# Technical Coordinator Report

DUNE Monthly Collaboration Call

October 6, 2017

# Multi-purpose Penetrations

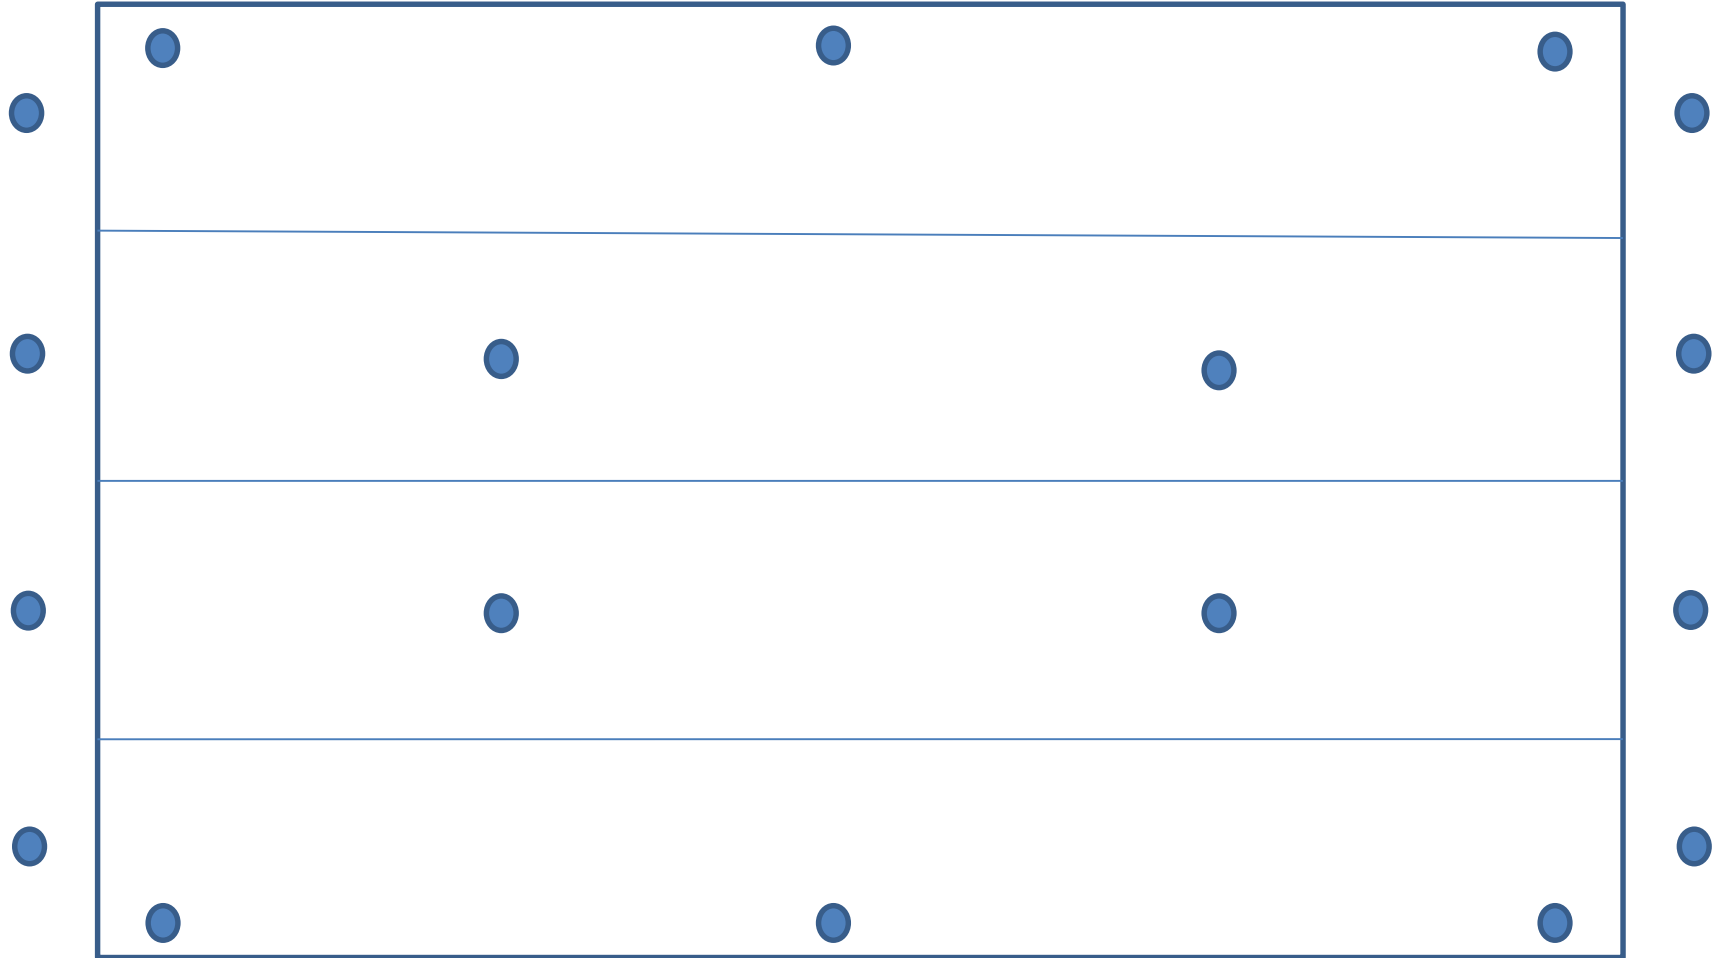
- The idea is to have a valve on the lower end of the penetration flange that can be closed and then later re-opened so that the instrumentation on the upper end of the flange can be swapped out
  - Implies a time-ordering as to when each penetration is utilized for different purposes
  - Most sensible for radioactive sources and warm cameras so that we can have a few of each that can be moved around to different locations

# Proposal II

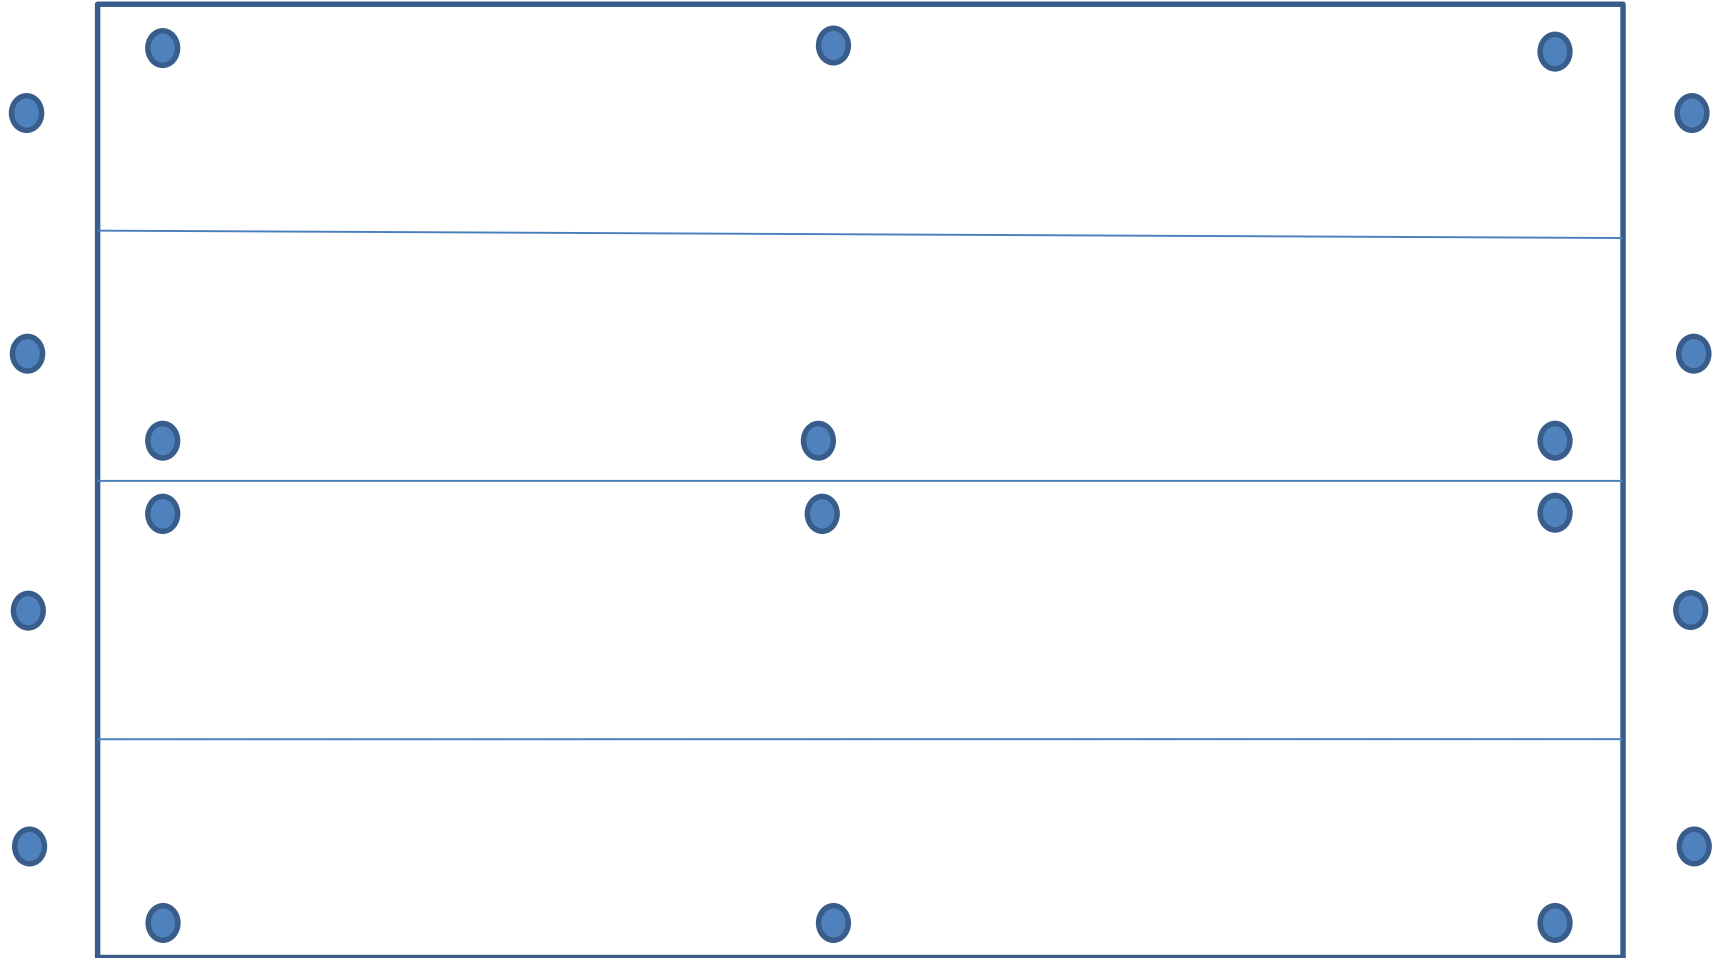
- Technical group is coming back to the consortia with a counter-proposal for a more limited number of multi-purpose penetrations
  - Somewhat constrained by the availability of only three open penetration locations along the outer APA walls
  - Requires some trade-off between the most ideal locations for the different systems that could take advantage of these penetrations – requires further consortia discussion
  - Two suggested configurations as shown on the following slides

- On the time scale of about a week, would like the consortia to consider preferences for Proposal I, Proposal II, or some “small” modification of these
- On a slightly longer time scale (a few weeks), attempt to understand and document the things we would be giving up by restricting ourselves to this more limited layout
- On the six month time scale be prepared to present justifications for a more complex layout
